**Subject:** RE: DO standard talking points (for your conversation with Melissa)

**Subject:** DO standard talking points (for your conversation with Melissa)

## DO Standard Talking Points:

Refer Melissa to Figure 14 (page 44) in the TMDL (copied below).

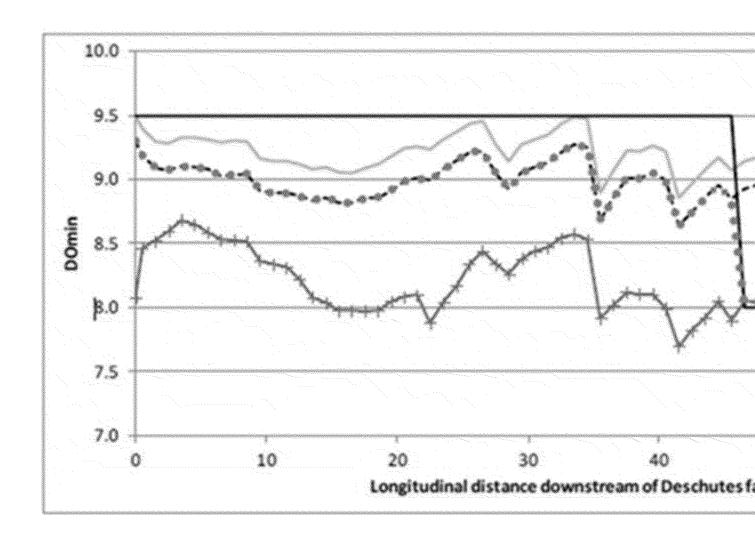
- □ □ □ □ □ □ □ Looks like Ecology used a 1-way R for DO in this TMDL. We need to give this a closer look, but it appears that Ecology used the estimated natural condition as the TMDL target from RM 1-48 (green line), and switched to the existing condition & numeric standard (whichever is more protective) at RM 48, when the DO standard decreases from 9.5 to 8.0, even though the estimated natural condition would be more protective in the lower portion of the watershed.

- •□□□□□□□□□ EPA staff (Chris & Laurie) have talked to Andrew & his staff at SWRO and Chad Brown about this. Chad agrees that this may be a 1-way R. Ecology asked us to talk with our standards folks about this. We have done that.

- •□□□□□□□ SWRO indicated that they are willing to "fix" the TMDL, but aren't willing do the kind of fix that would require another public notice.
- • • How does this interpretation of the standard mesh with the conversations Ecology is having with NWEA about the NCC provision?

- •□□□□□□□□□ EPA is concerned that EAP staff (Mindy?) working on the Budd Inlet Capitol Lake TMDL (downstream of this TMDL) may not be aware of the 1-way R issue, as it might be applied to DO TMDLs. Development of that TMDL is currently underway.
